IREDELL COUNTY HEALTH DEPARTMENT

IMPROVEMENT PERMIT / AUTHORIZATION TO CONSTRUCT / OPERATION PERMIT / EXISTING SYSTEM INSPECTION

PERMIT# 076214 PIN# 4658271342

ADDRESS 326 Bailey Rd Mooresville

INITIAL SITE SKETCH

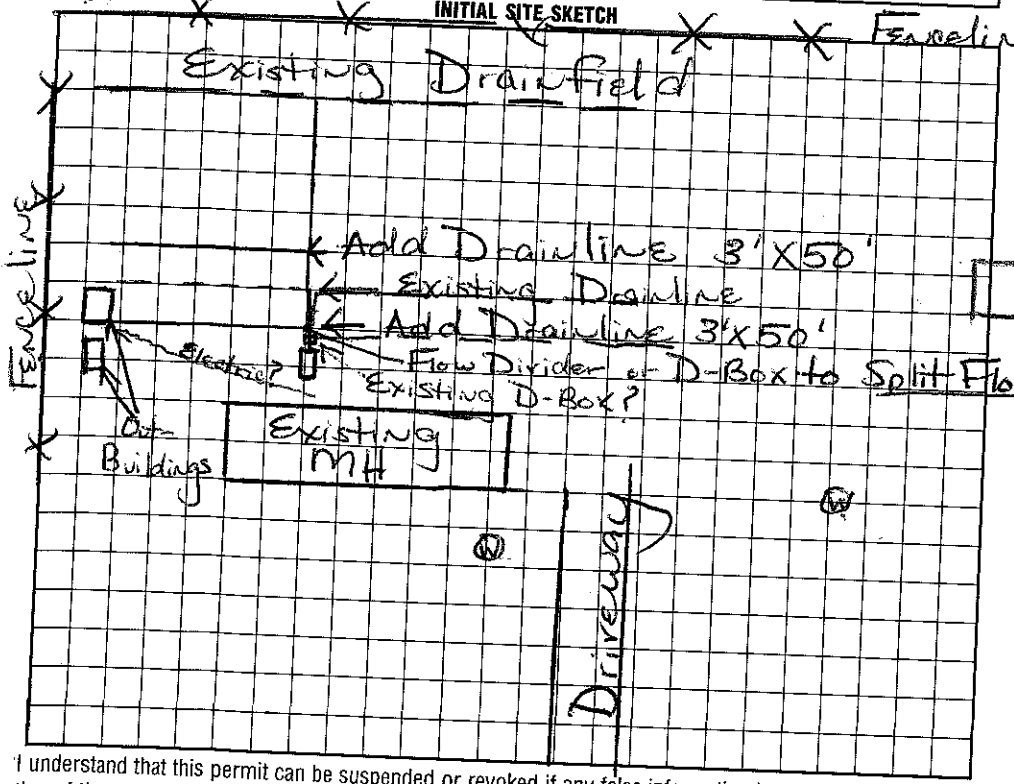
Comments:/Conditions: Upgrade to 4 Bedroom
Add 2 lines at 50' each (Split Flow btw 2 new lines)
Not to Scale

Comments:/Conditions: Existing MH will be removed. Septic System appeared to be functioning okay at time of inspection, however some signs of past failures.

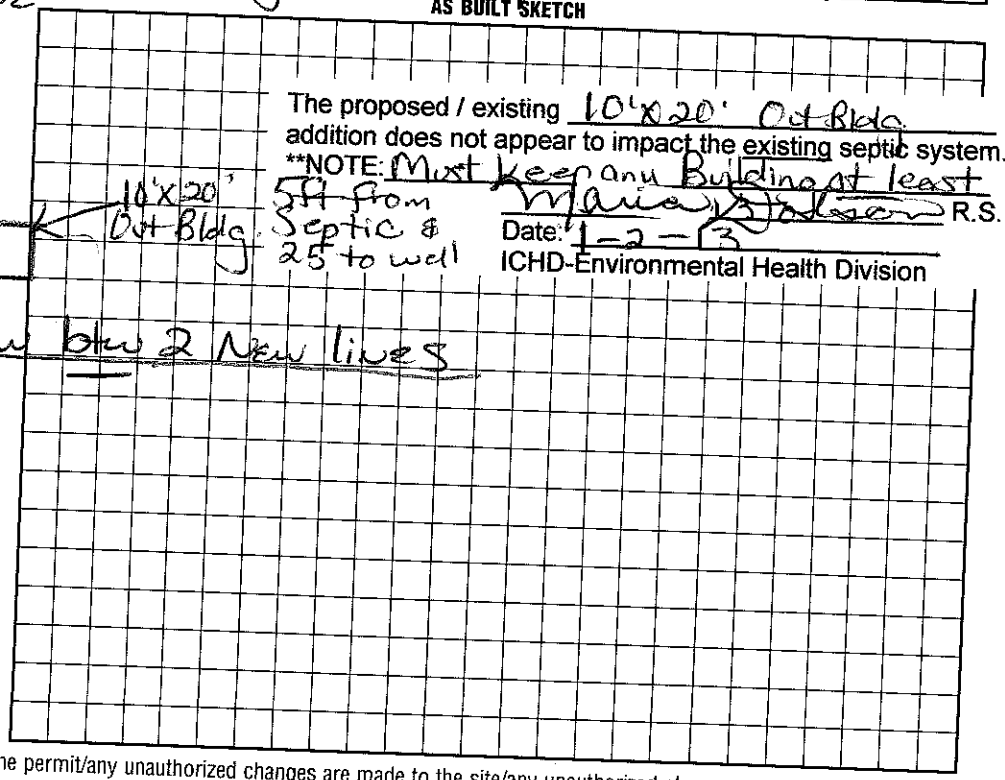
The proposed / existing 10'X20' Out Bldg. addition does not appear to impact the existing septic system.

**NOTE: Must keep any Building at least 5ft from Septic & 25 to well
